Office Action Summary	Application No. 10/633,295	Applicant(s) WOOD ET AL.	
	Examiner Tan Le	Art Unit 3632

DETAILED ACTION

Claims 1-2, 4, 12, 27, 44 and 46 are rejected under 35 U.S.C. 103(a) as being unpatentable over US Patent no. 6,195,811 to Dragovic.

FIG. 4

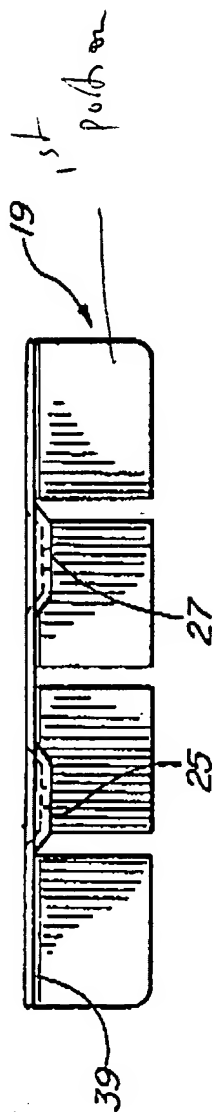
As to claims 1-2 and 27, Dragovic teaches a bracket (see Fig. 2-7) substantially as claimed which comprises a first portion (21); a second portion (23) configured to adhere to a support structure, the second portion extending outwardly from the first portion to form an enclosed angle therebetween, the second portion having an inner surface adjacent to the enclosed angle and an outer surface opposite from the inner surface, wherein a second portion includes a plurality of separation features (25, 27) (Fig. 3), the separation features projecting inwardly from the inner surface, the separation features including at least one of dimples and ridges (see attached Figure

6), configured to separate the second portion from the support structure by a predetermined amount, wherein the plurality of separation features maintains separation by a predetermined amount. Dragovic also teaches an adhesive (37) for adhering between the second portion and the support structure, the size of plurality of separations features is inherently based on an amount of adhesive (37).

As to claims 4 and 12, Dragovic also teaches the plurality of separation feature including a plurality of dimples (see Fig. 6) and the bracket can be either formed by one of molding or extruding (see Col. 2, 25-29). Note that the recitations such as "the process of adhering the second portion to the support structure (claim 1, lines 13-14) or the recitation "formed by one of molding or extruding" (claim 12; lines 1-2) are method limitations in the article claims. The method of forming or processing is not germane to the issue of patentability of the device itself. Therefore, this limitation has not been given patentable weight.
